Pro L12000Q/L12002Q/L20000U/L20002U

Firmware Release Notes

January 7th 2021

This is to inform about release of firmware Ver.3.00. (All previous versions are included in v3.00)

[Before update](#)

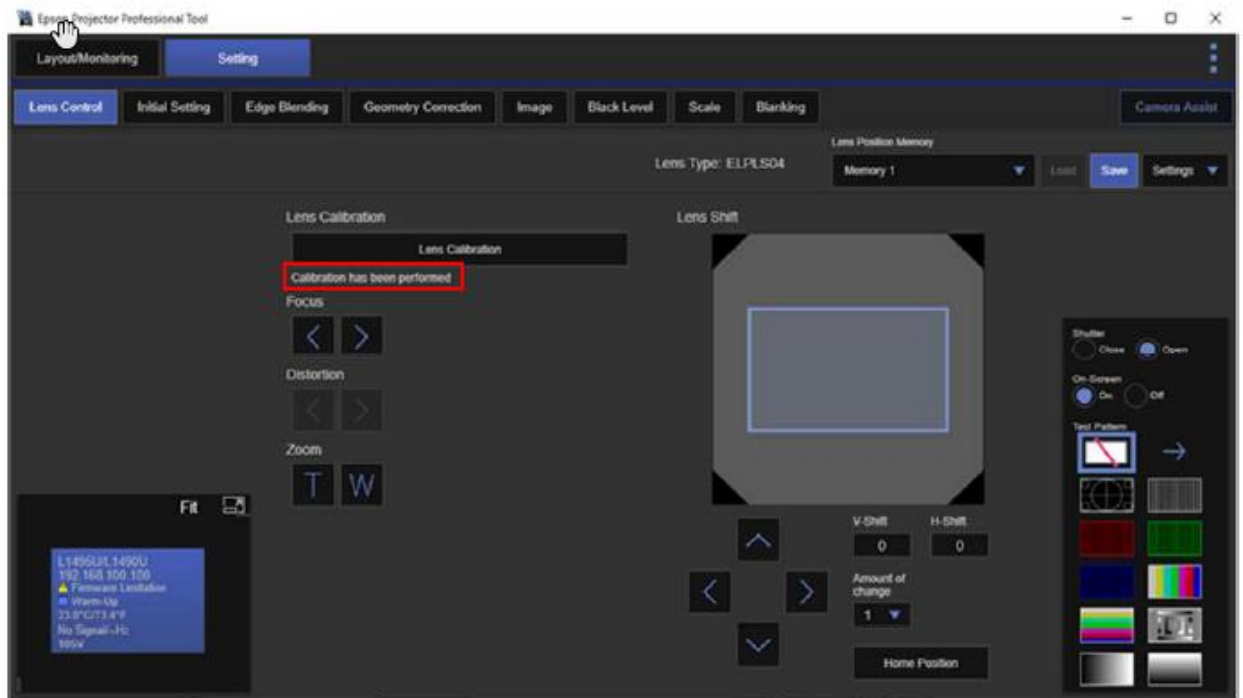
25) (Multi-projection function)

Changed the color and size of the black level adjustment window when ""Color adjustment"" is

selected under the black level adjustment menu*

*Color matching and color uniformity menu window are also changed to same configuration.

<Background>

Black level adjustment window is too bright which affects the adjustment of the black level around the window.
